**MENDOCINO HISTORICAL REVIEW BOARD
STAFF REPORT**

**JULY 1, 2019
MHRB_2016-0018**

PROJECT DESCRIPTION: A Mendocino Historical Review Board Permit request to demolish, reconstruct, and/or construct the Ferro House, garage, tower, fencing, driveway and other structures. Note: Mendocino Town Plan Appendix 1 lists the site as a Category IIa Historic Resource.

STREET ADDRESS: 45270 Albion Street, Mendocino (APN: 119-217-06)

**HOUSE - NORTH ELEVATIONS -
EXISTING & PROPOSED**

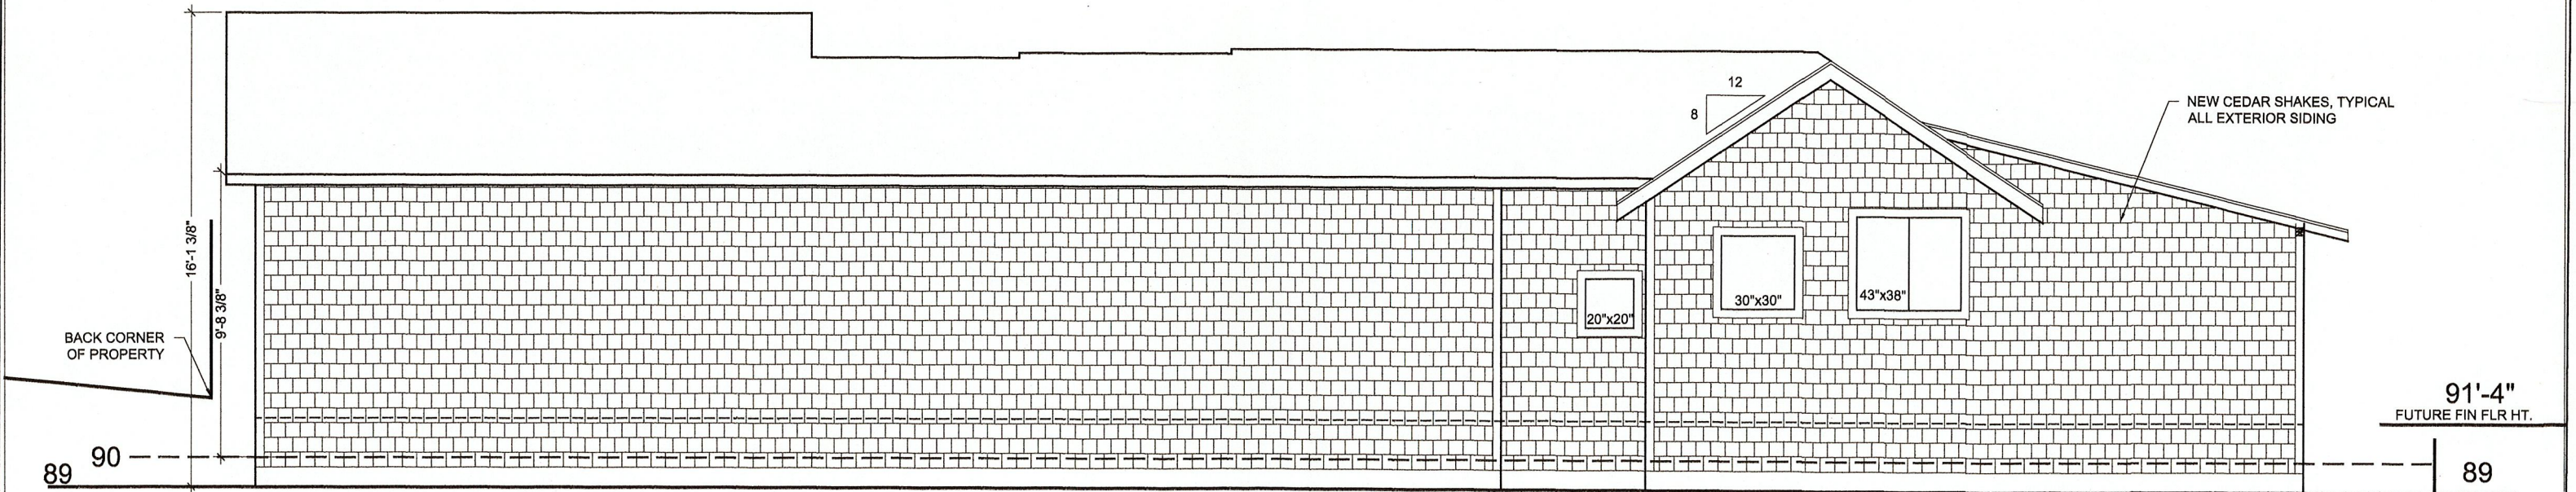
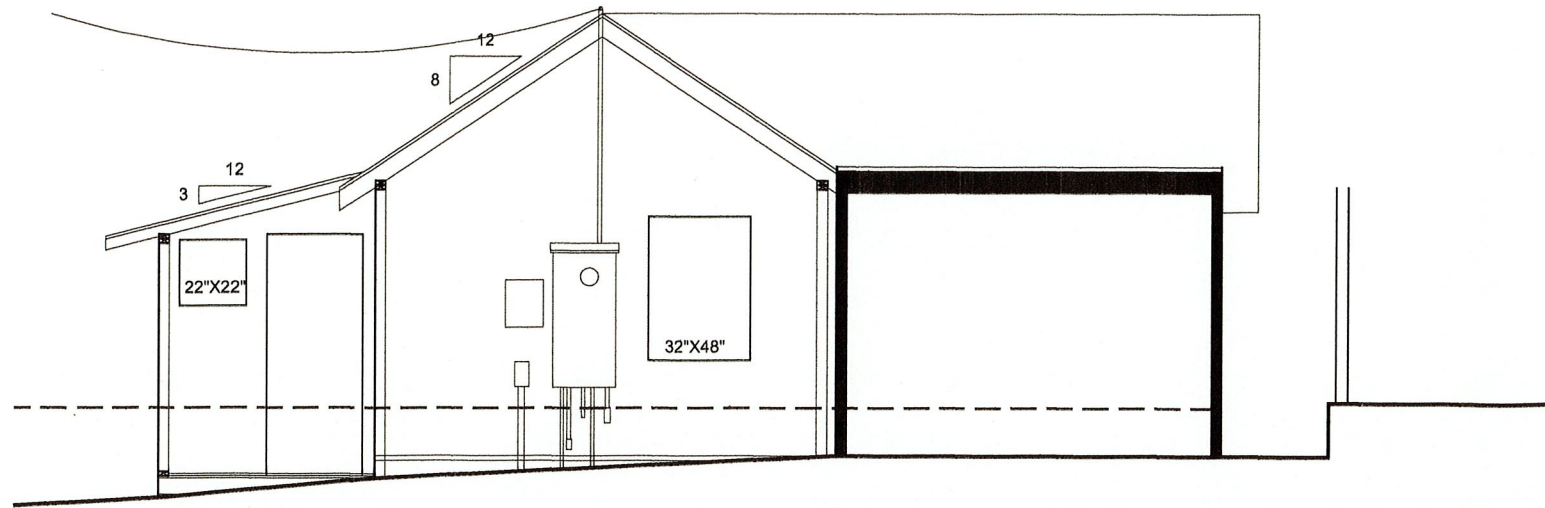
Proposed House Restoration and New Construction. The siding to the house (cabin, mudroom, additions) would be cedar shingles with oil finish to help preserve the material. Redwood trim would be painted forest green. The cabin, mudroom, and additions would be reconstructed in the existing foot print. The rooflines would be reconstructed with the same 8:12 pitch as shown on the as-built plans, except the circa 1980 addition with flat roofs would be rebuilt with a 8:12 pitched gabled roof running east west. Asphalt shingles would be used throughout. Existing windows would be replaced with wood-frame windows having mostly the same size, style, and shape. Windows would be placed within the proposed dormers. Doors would be replaced with painted fiberglass doors. See Sheet No.'s A2 through A5 for existing and proposed elevations of the house.

10. To the satisfaction of the Director of Planning and Building Services, exterior house building plans shall provide sufficient detail for the successful reconstruction of the cabin, mudroom, and additions with an 8:12 gabled roofline.

SHEET NAME:
**TOWER NORTH & EAST ELEVATIONS -
EXISTING & PROPOSED**

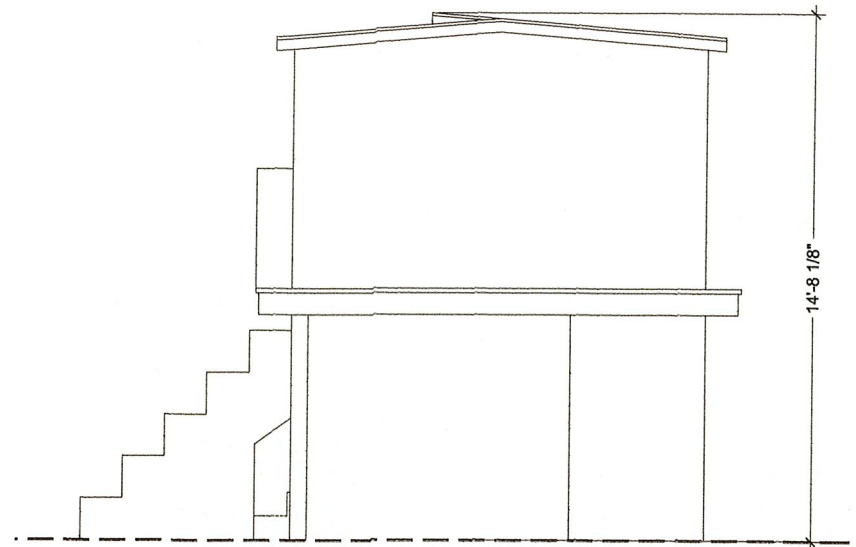
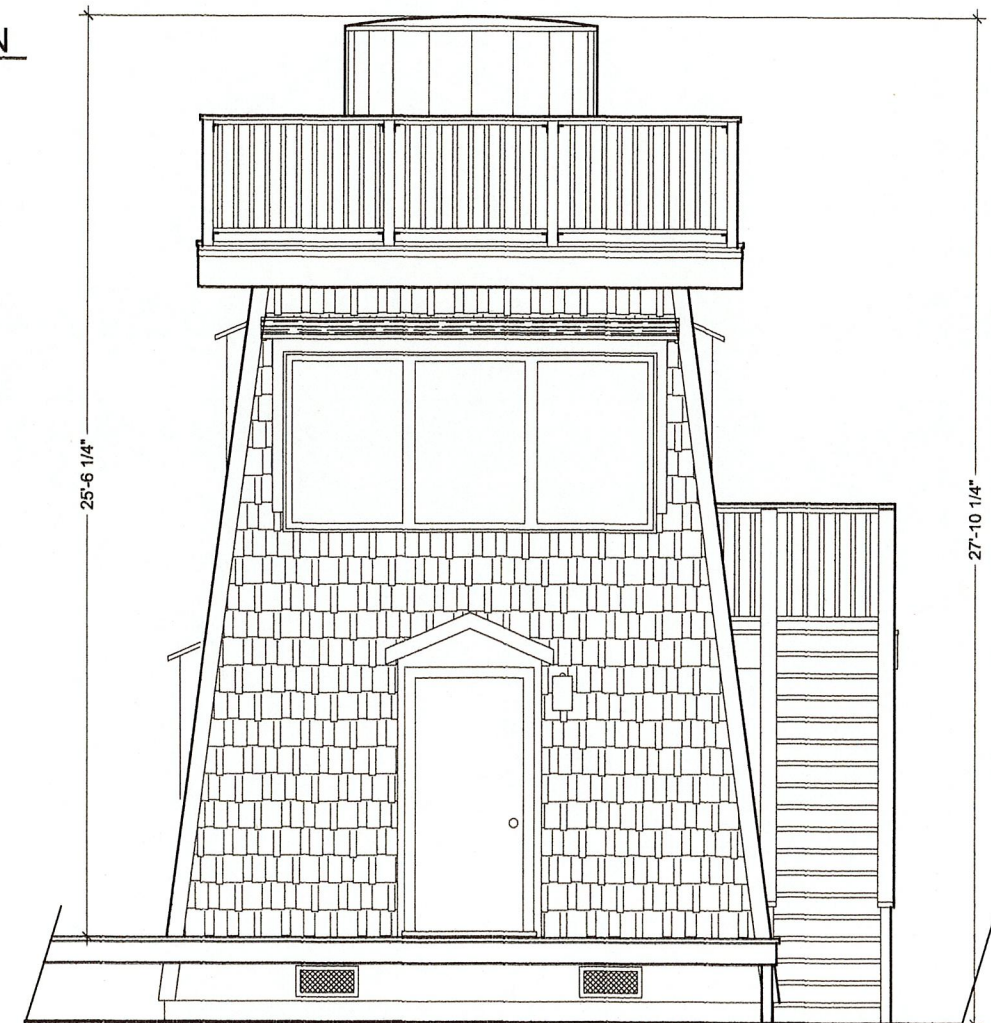
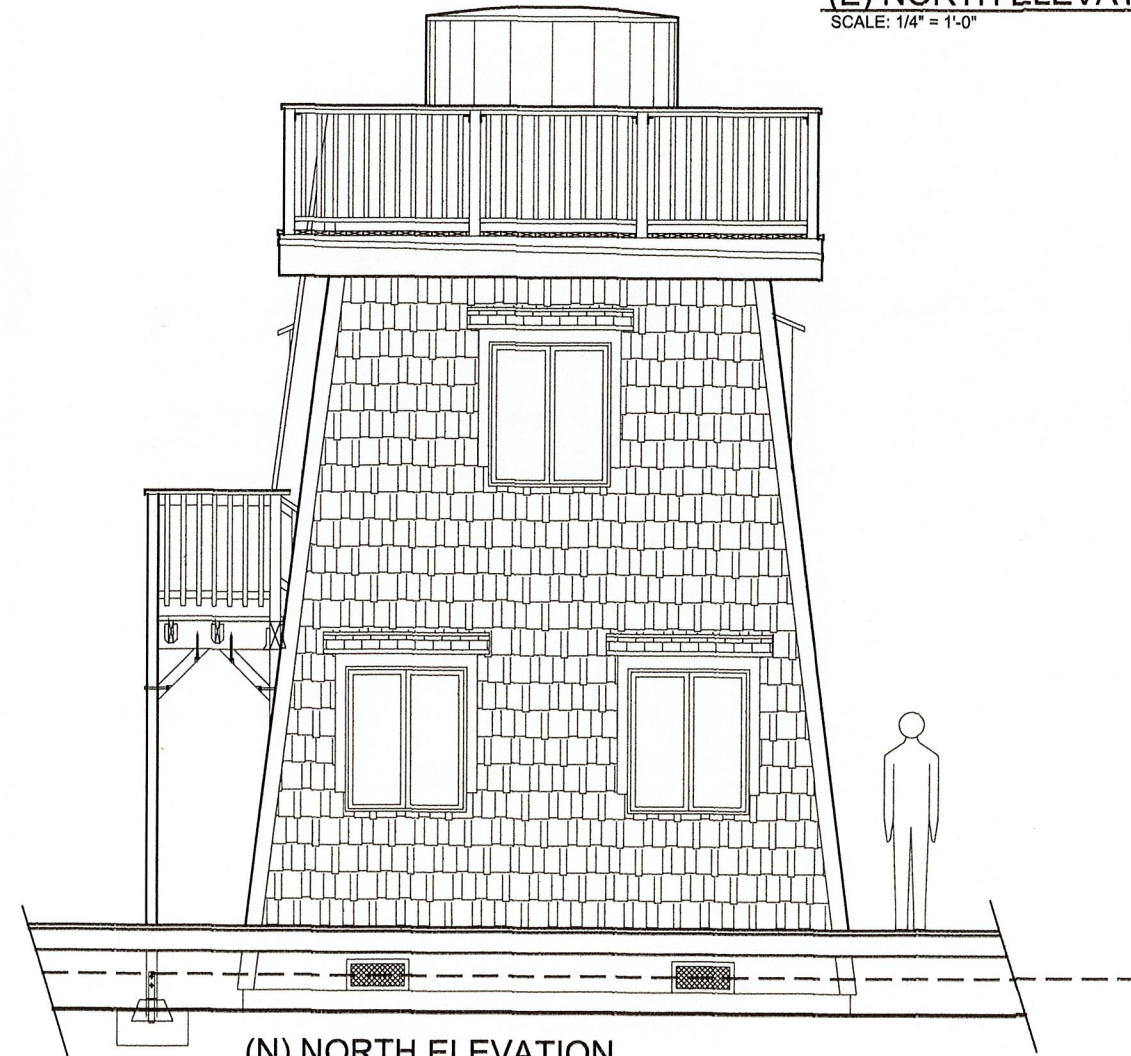
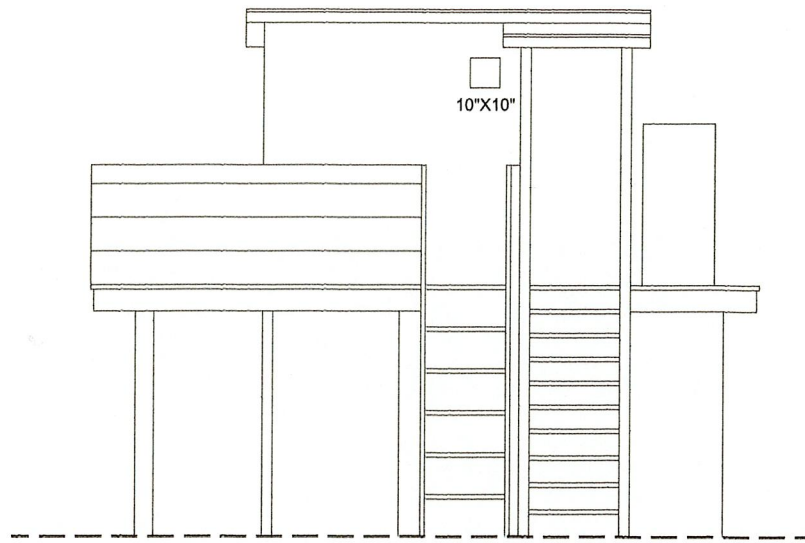
Existing Tower. The circa 1900 water tower is 14 feet in height and irregularly shaped (See Sheet No.'s A6 and A7 Tower Elevations). It has a footprint of approximately 200 square feet and has three entrances, two on the primary level, and one on the second level, with both interior and exterior stair cases to the second level. The overall condition of the tower is poor (CHRC 2016).

As an accessory structure, the proposed 28 foot tall tower footprint would be 290 square feet. The siding on the tower would be cedar and the trim would be painted forest green. The tower would have an exterior door on each level with an external staircase projecting from the building footprint. A new 2,800-gallon water storage tank would be located atop the tower. The proposed water storage tank exterior would be lined with redwood slats and enclosed with metal bands. The proposed tower would be 28 feet in height above grade including the additional height of the water storage tank.

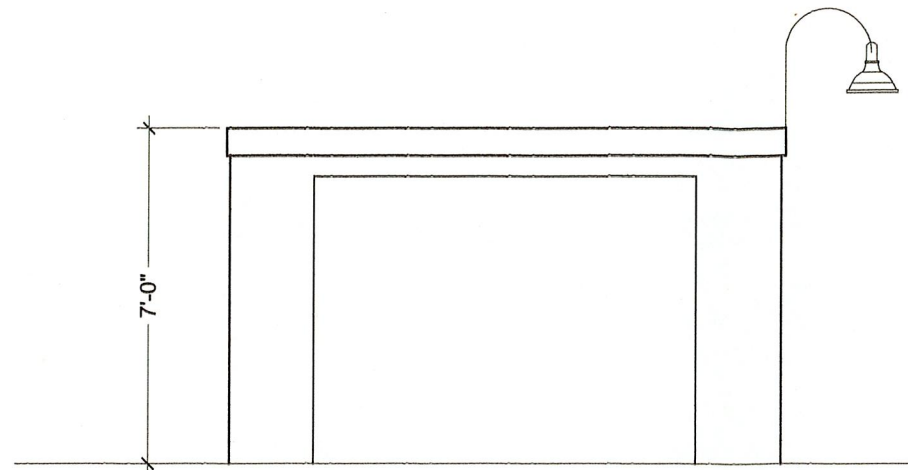
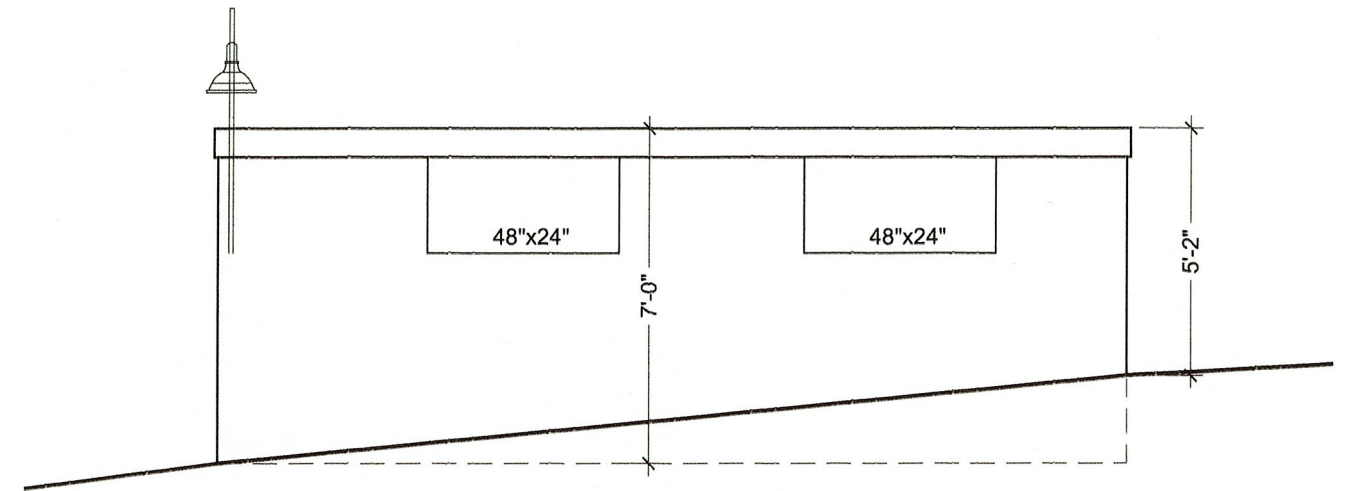
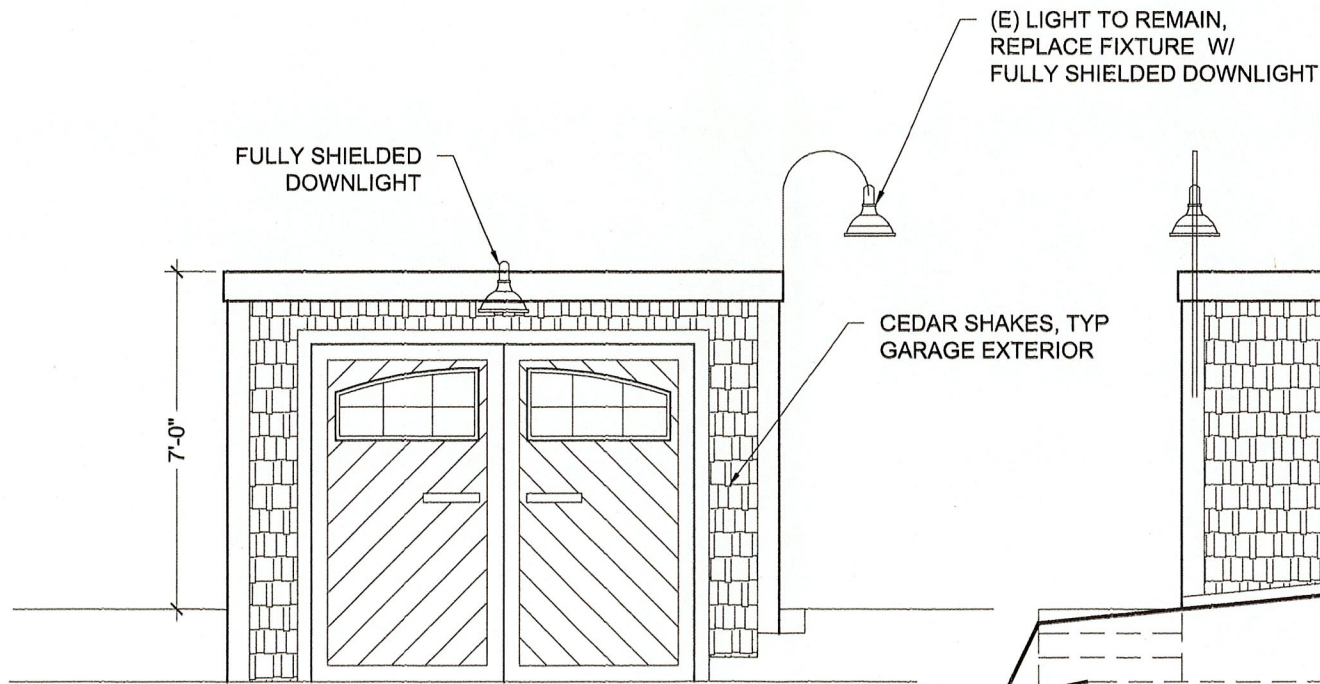
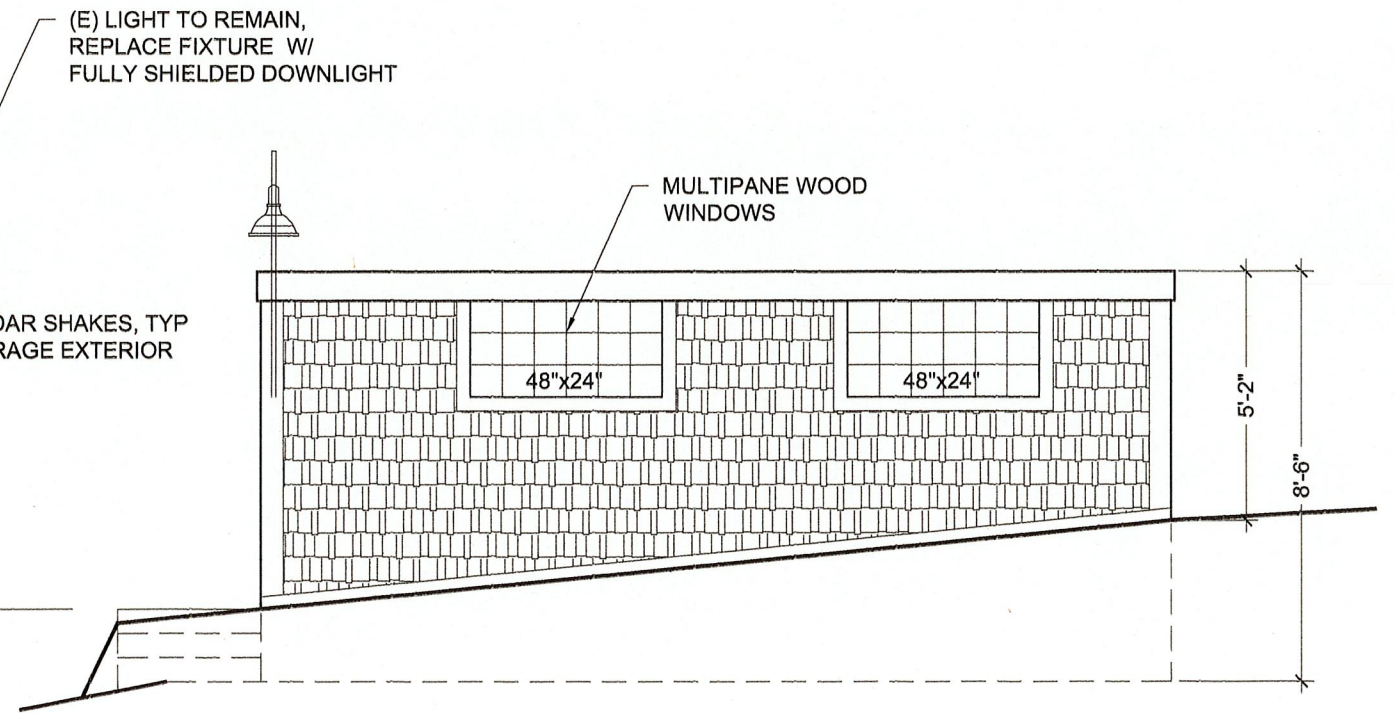
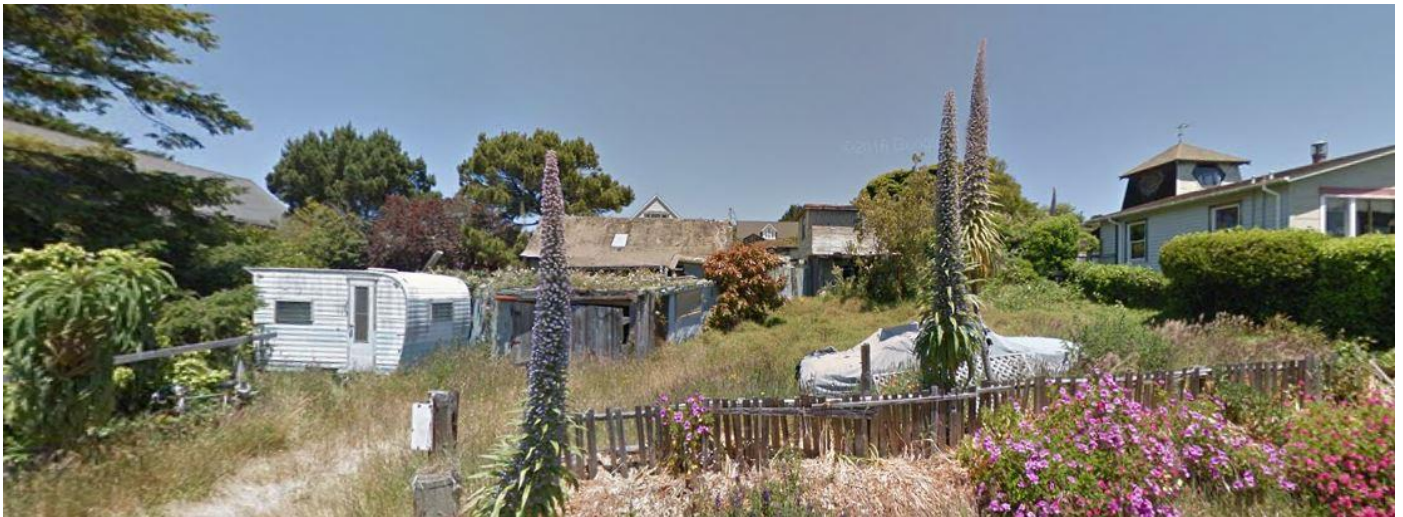
Existing Garage. The garage is approximately 12 feet by 20 feet and is built with a mixture of 2 inch by 12 inch wood boards, plywood, and corrugated metal siding (See Sheet No. A8 Garage Elevations and Floorplan). The south elevation is 7 feet tall; the north wall varies between 5.3 feet and 5.6 feet tall. It has a flat, sheet-metal roof covered in tar. The garage stands on a post foundation and has a dirt floor. A large, now defunct concrete lined well has been dug into the center of the floor. Wooden framework around the well has rotted extensively and has exposed tunneling below the floor. The garage door is composed of vertical 2 inch by 12 inch on-gate hinges. A rectangular window opening on the east wall has been covered by corrugated fiberglass paneling. The overall condition of the garage is poor (CHRC 2016).

Proposed Garage Restoration. The siding on the garage would be cedar shingles with redwood trim painted forest green (See Sheet No. A8 Garage Elevations and Floorplan). The flat roof of the garage would be rebuilt to the same shape and style. The floor of the garage would have the pit and tunneling removed and then covered with a cement slab. Windows on the garage would be replaced with multipane wood windows as shown on the elevations.

11. To the satisfaction of the Director of Planning and Building Services, exterior garage building plans shall provide sufficient detail for the successful reconstruction of the garage with a flat roofline.
